STATE OF TENNESSEE
DEPARTMENT OF TRANSPORTATION
BUREAU OF ENGINEERING

I-65 INTERCHANGE AT BUCKNER ROAD
IN SPRING HILL (DESIGN-BUILD)

REV. 09/14/20: REVISED INDEX OF SHEETS.

TYPE	YEAR	PROJECT NO.	SHEET NO.
FUNCT.	2020		5A

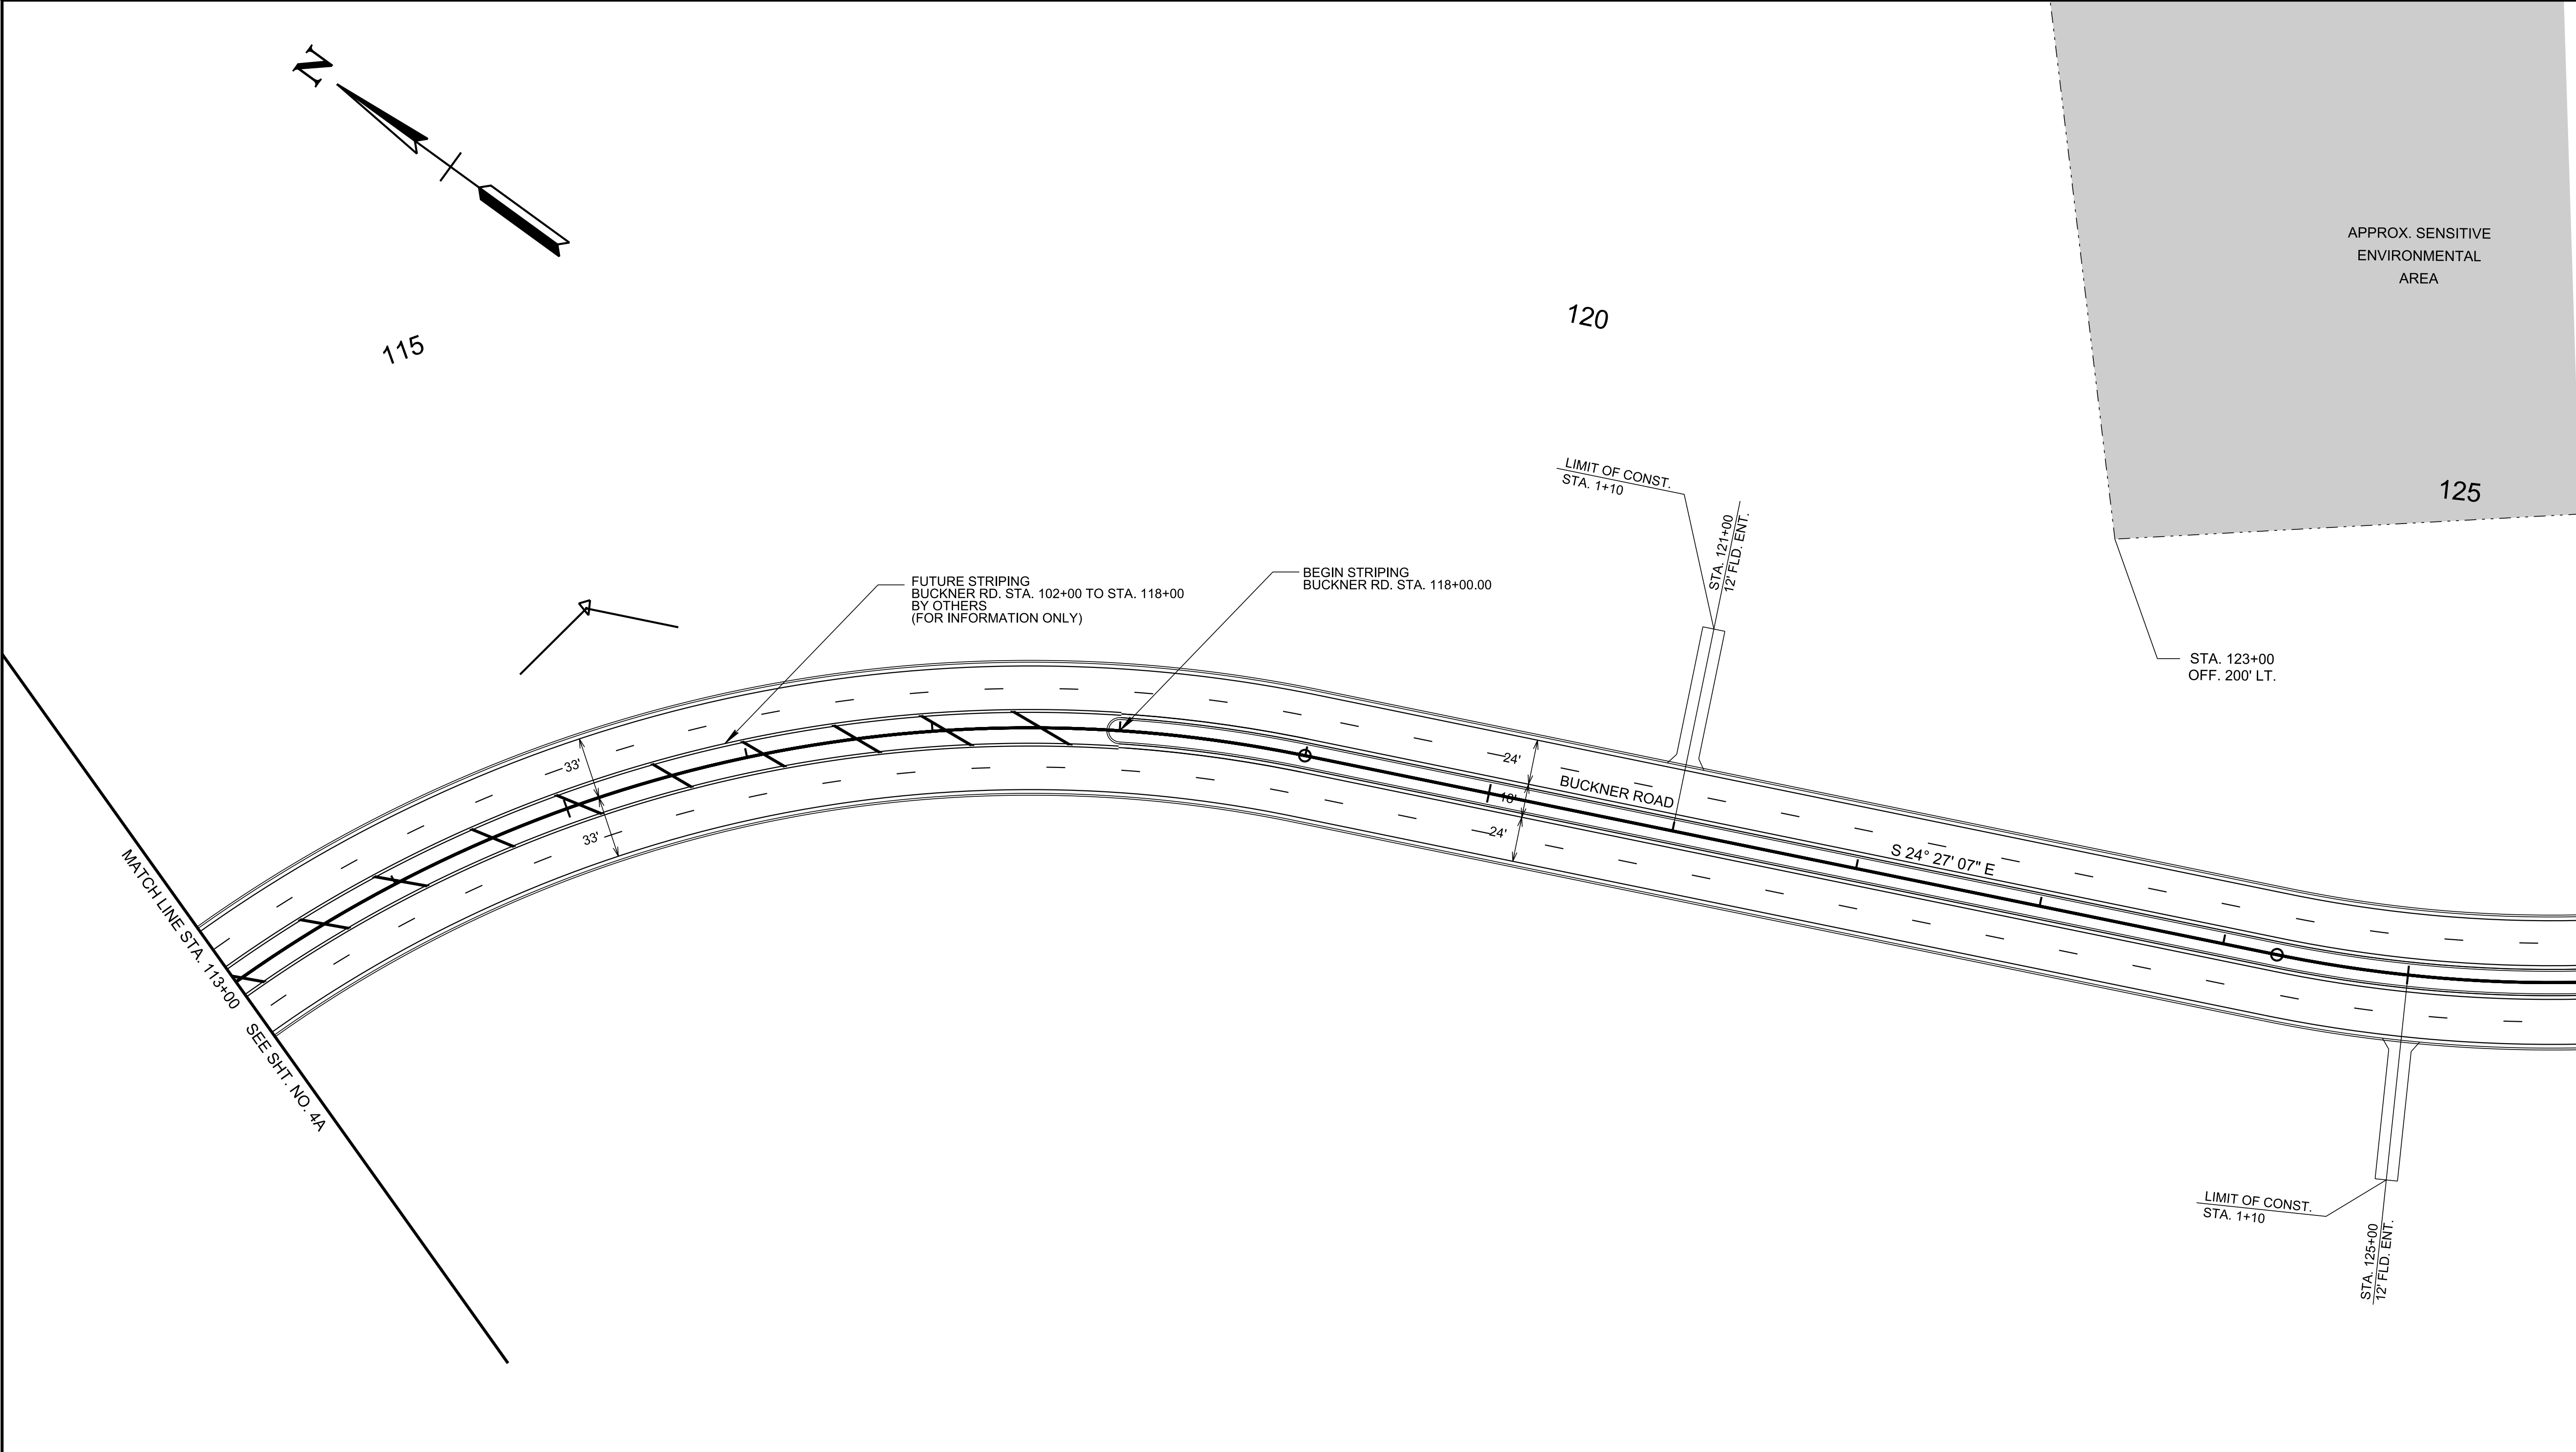
REV. 09/14/20: ADDED FIELD ENTRANCES TO TRACT NO. 15.

TYPE	YEAR	PROJECT NO.	SHEET NO.
FUNCT.	2020		6A

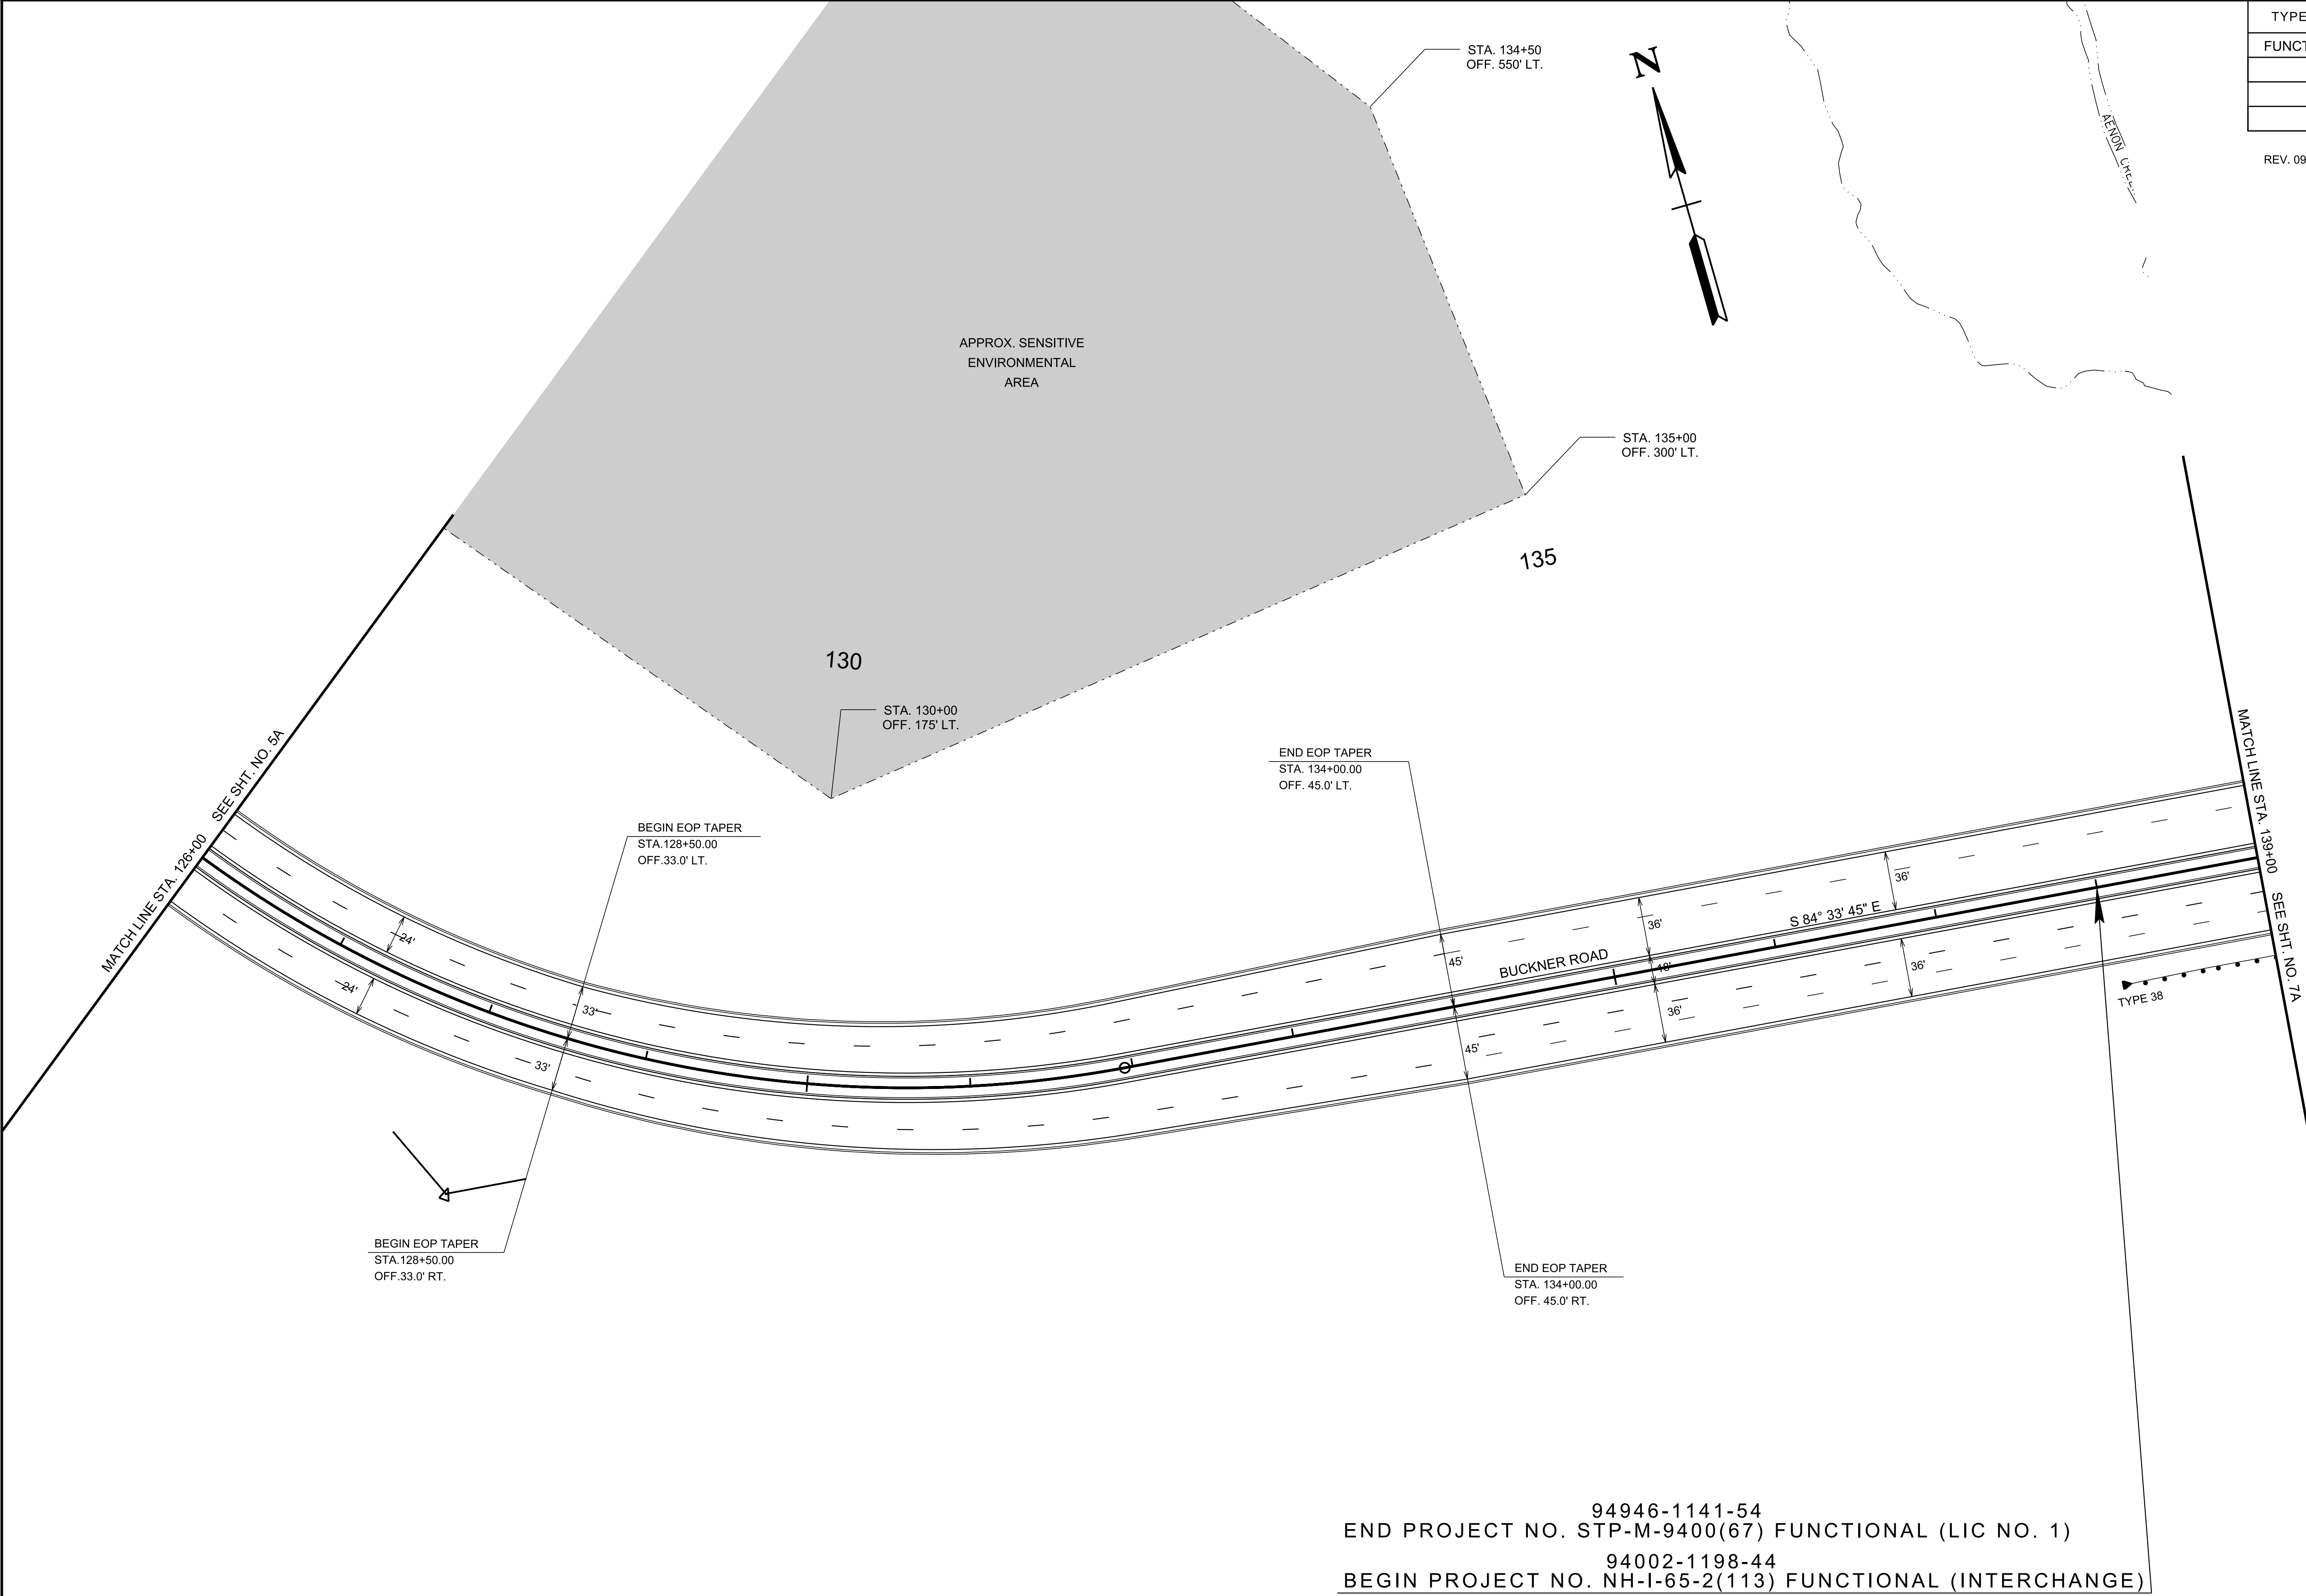
REV. 09/14/20: REVISED GUARDRAIL.

TYPE	YEAR	PROJECT NO.	SHEET NO.
FUNCT.	2020		7A

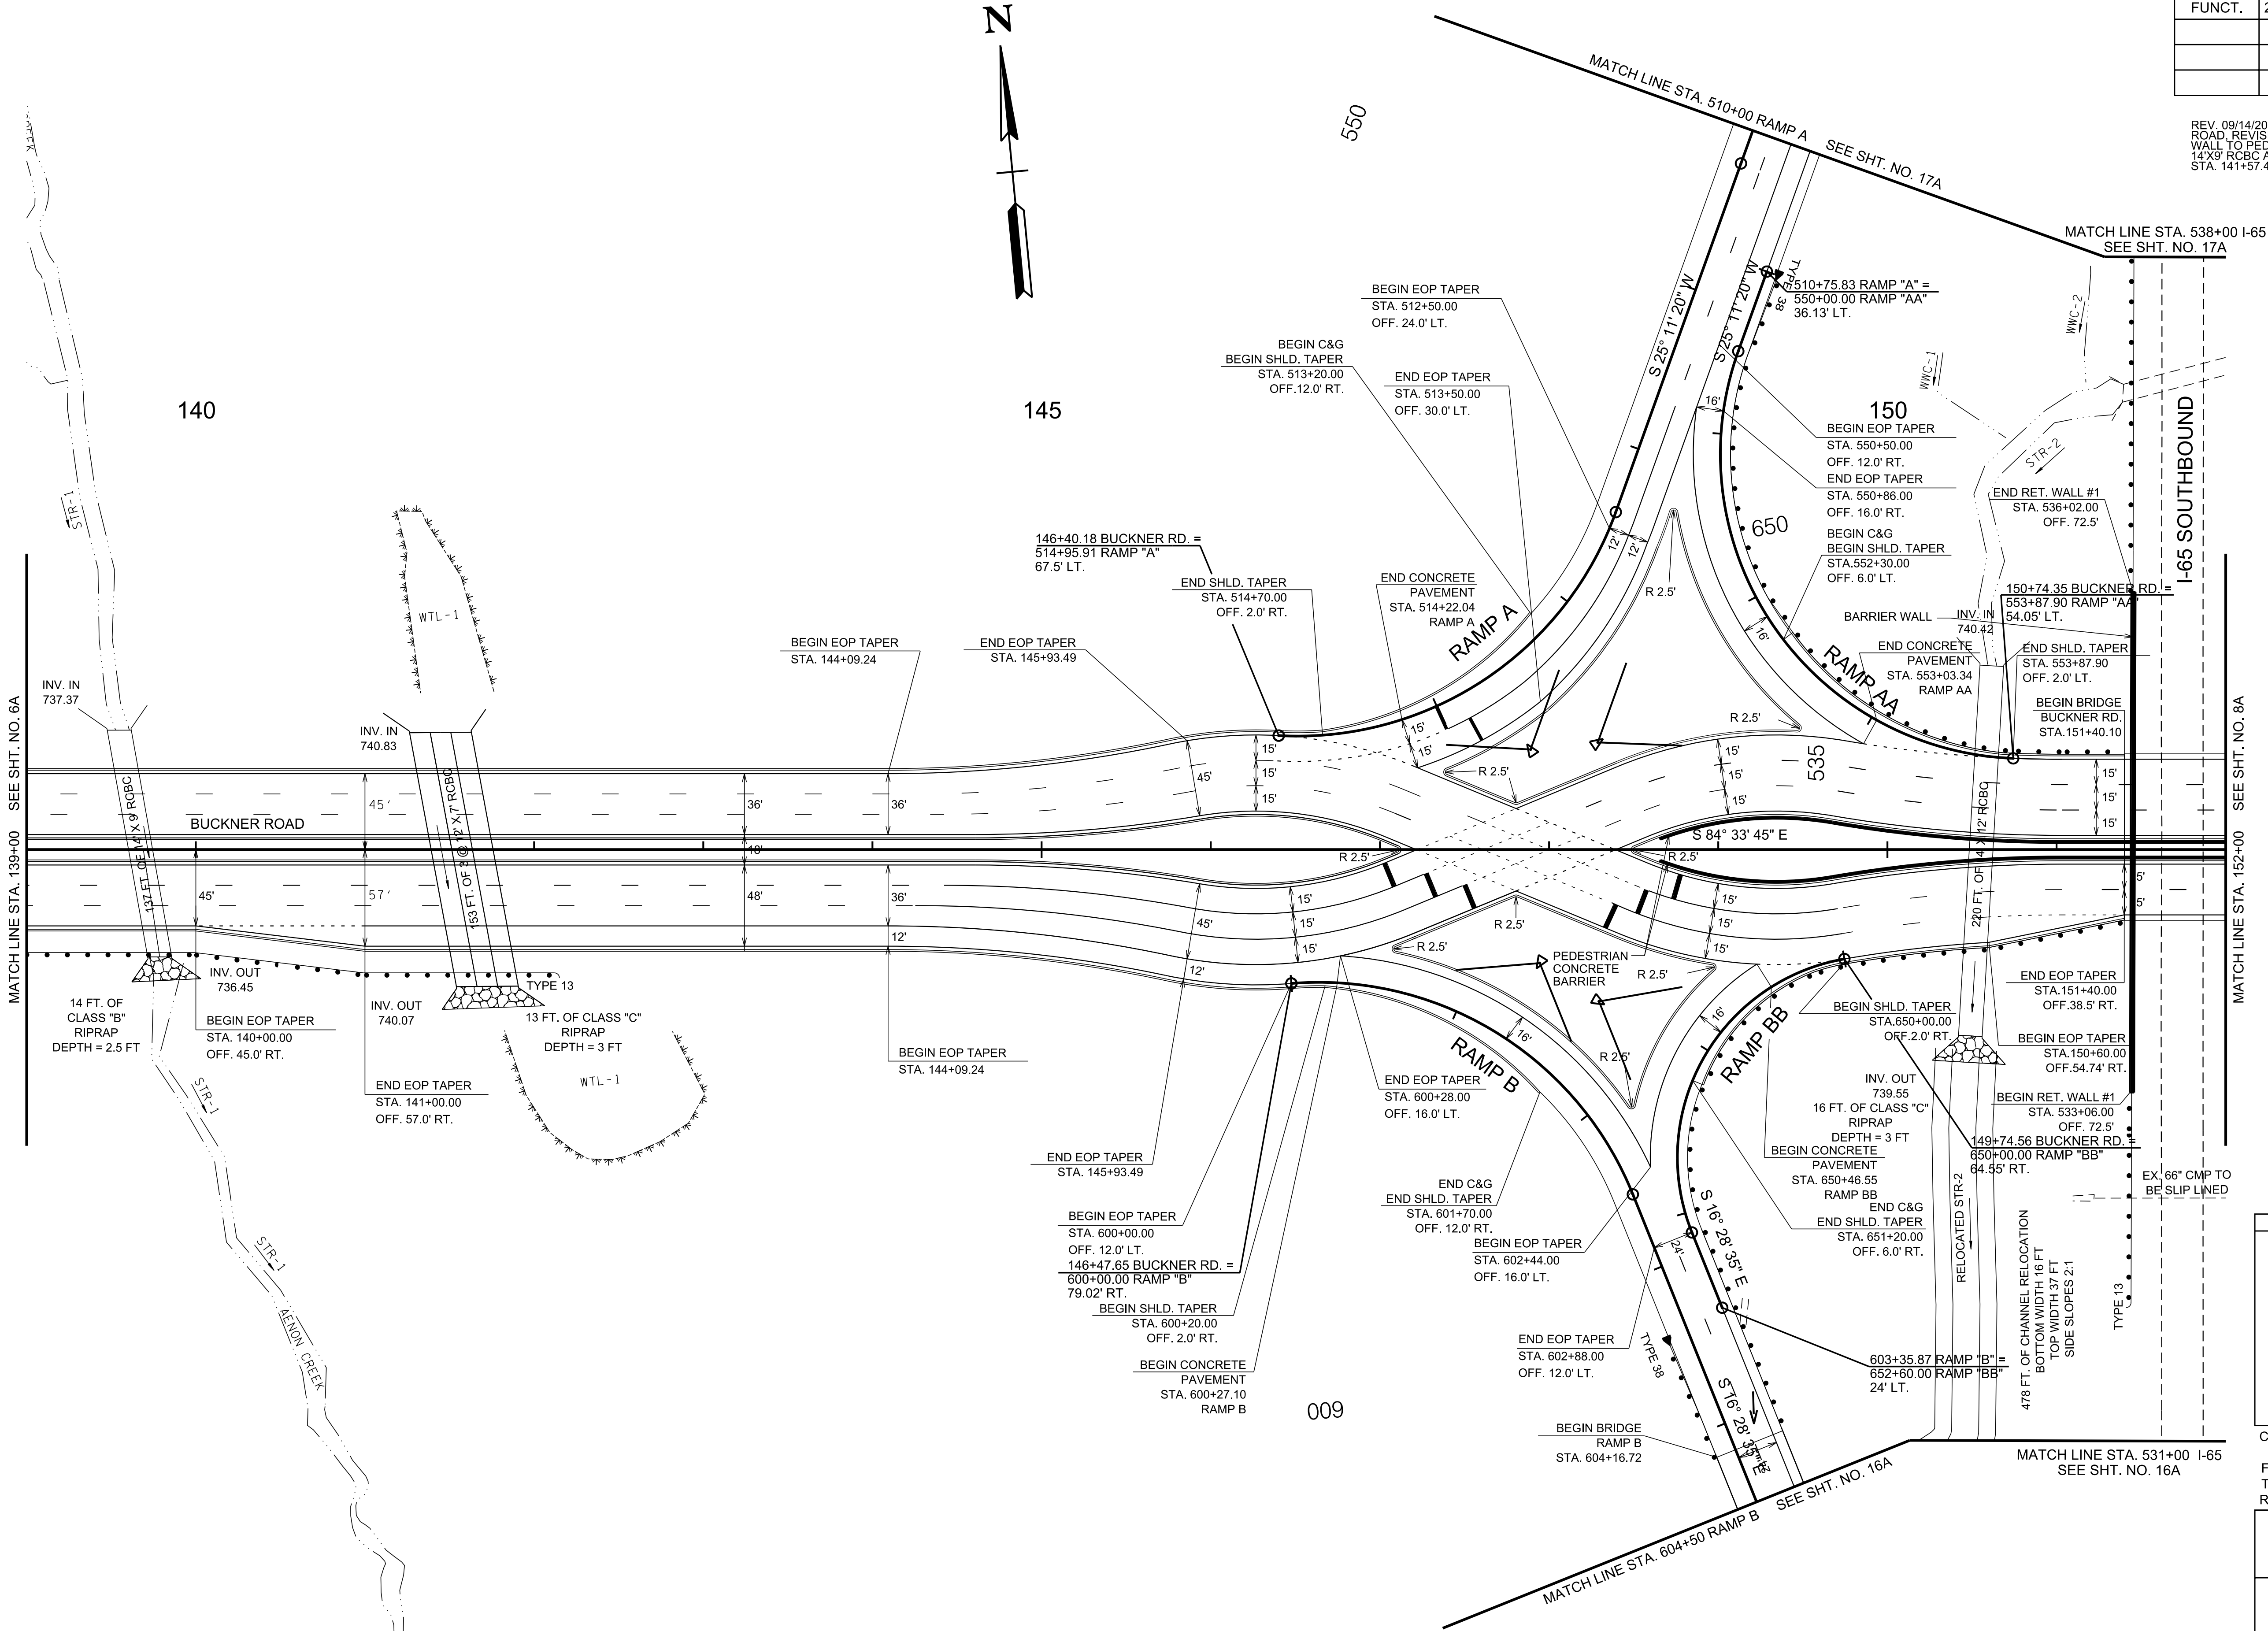
REV. 09/14/20: REVISED GUARDRAIL ALONG BUCKNER ROAD. REVISED 51" SINGLE SLOPE BARRIER HALF WALL TO PEDESTRIAN CONCRETE BARRIER. REVISED 14'X9' RCBC AT STA. 139+67.38 AND 12'X7' RCBC AT STA. 141+57.44.
